Sandstone Precinct Modification 7

Internal and external design changes to the Education
Building
State Significant Development Modification Assessment
(SSD 7484 MOD 7)

June 2020

Published by the NSW Department of Planning, Industry and Environment

Figure 6 | Approved location of substation chamber in Farrer Place (Source: D/206/1641)

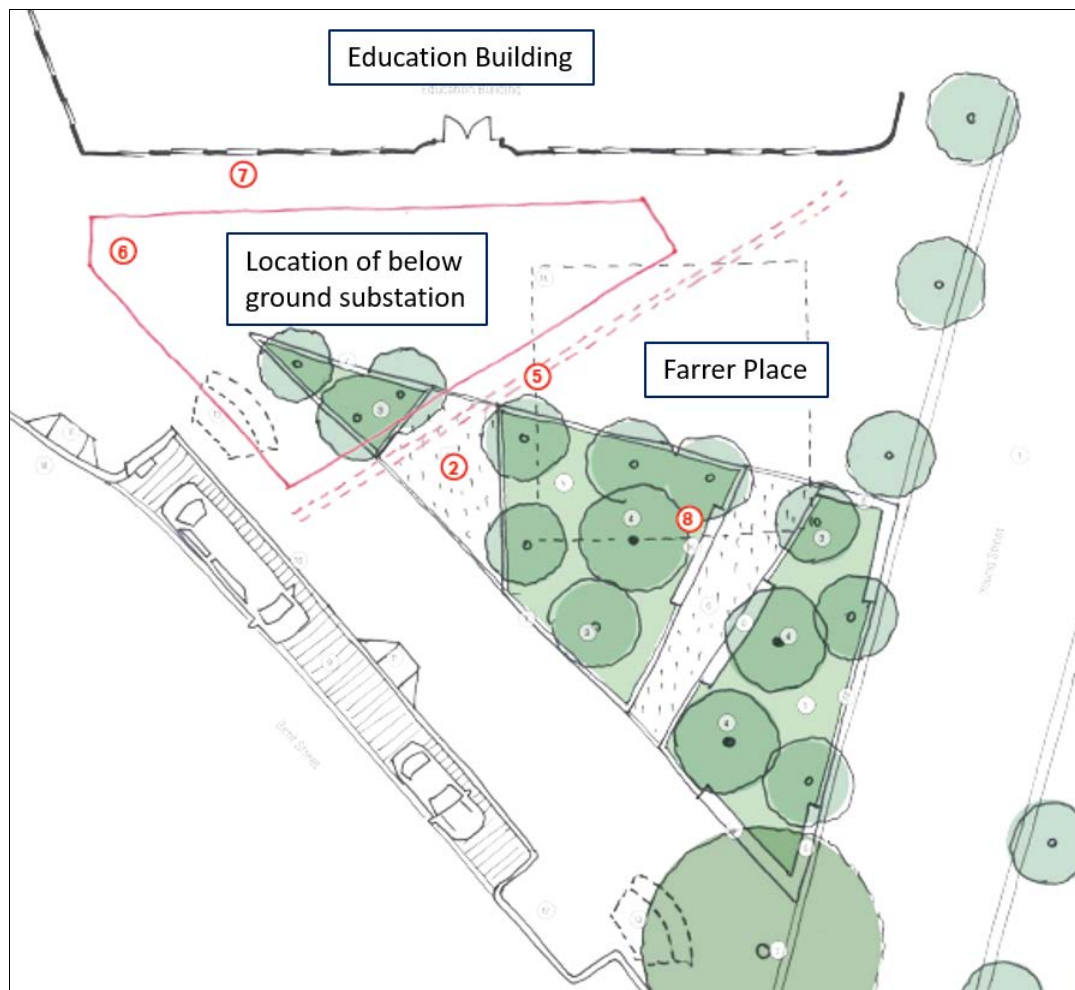
The adaptive re-use of the Sandstone Precinct requires a new substation. As outlined in **Section 1.3**, the development consent issued by Council for public domain works in Farrer Place included a below ground substation reusing the space of an existing decommissioned substation (**Figure 6**).

The Applicant notes significant above ground ventilation stacks and access would be required in Farrer Place to satisfy Ausgrid requirements. The Applicant also notes the above ground elements were inconsistent with its intent for Farrer Place to be a high-quality space at the hotel's front door. In addition, Council advised it would not support any above ground substation related infrastructure in Farrer Place.

Figure 7 | Proposed substation chamber, lower ground level (Source: MOD 7 Design Report)

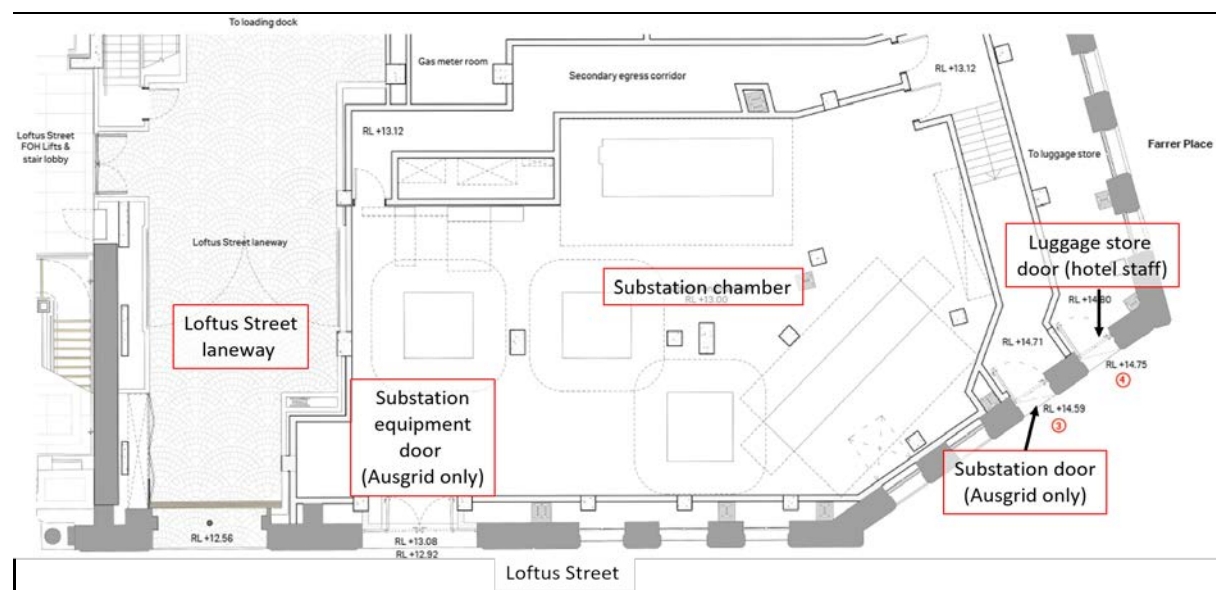
The proposal therefore seeks to relocate the substation from Farrer Place to the south west corner of the Education Building at the lower ground floor, replacing a bar approved in this location (**Figure 7**).

The relocation of the substation into the building requires modifications to exceptionally significant heritage fabric in the south-west corner of the building, however the Department is satisfied the impacts are acceptable as:

- the proposal is consistent with the CMP, which permits work to exceptionally significant fabric where it is necessary for the effective reuse and function of the building
- impacts to the heritage fabric have been minimised as much as possible by utilising existing openings in the building and limiting work to heritage fabric

- the changes to the Bent Street and Loftus Street building elevations will not significantly alter the external appearance of these facades as:
 - o the new access doors will be finished to match existing heritage windows and doors on the building

- o the air intake louvres are in an existing ground floor heritage window and the existing Loftus Street laneway entry and concealed with a decorative screen to mitigate views

- o a film to the windows will reduce views from the street into the substation chamber and existing decorative grilles are retained to maintain the window appearance.

- it provides an improved public domain outcome, by contrast to integration of ventilation and substation access into the public domain design, which would significantly compromise the quality of the new upgraded public domain within Farrer Place

- the recommended conditions provided by Heritage NSW will ensure the works are undertaken in consultation with the project heritage consultant and original fabric removed is salvaged and retained on site for future use.
